MIL-M-28787/341
AMENDMENT 1
30 July 1993

MILITARY SPECIFICATION

MODULES, STANDARD ELECTRONIC

INTERFACE BUS, KEY CODE PHP

FIGURE 14. Receiver common mode test circuit for table X.

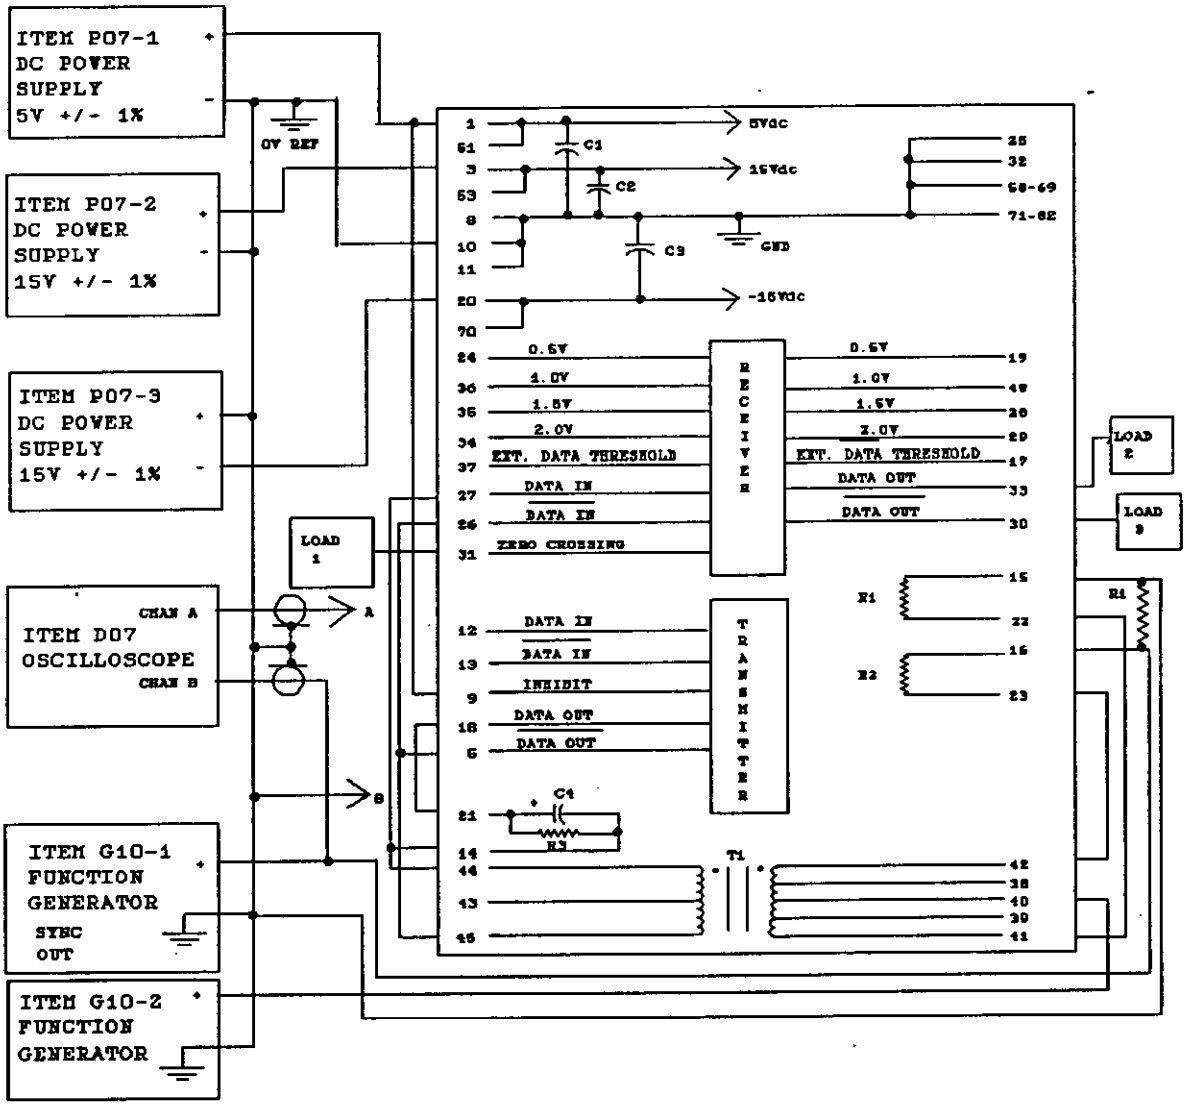
FIGURE 14: Delete and substitute new figure 14 as printed on page 3 of this amendment.

NOTES:
1. R1 = 35Ω ± 2%, 1/2 W, noninductive.
2. Load circuits 1, 2, and 3, are as shown on figure 11.
3. Item D07, CHAN B shall be operated in the inverted mode.
4. Modules which meet the requirements in table X, meet the common mode requirements of this specification.
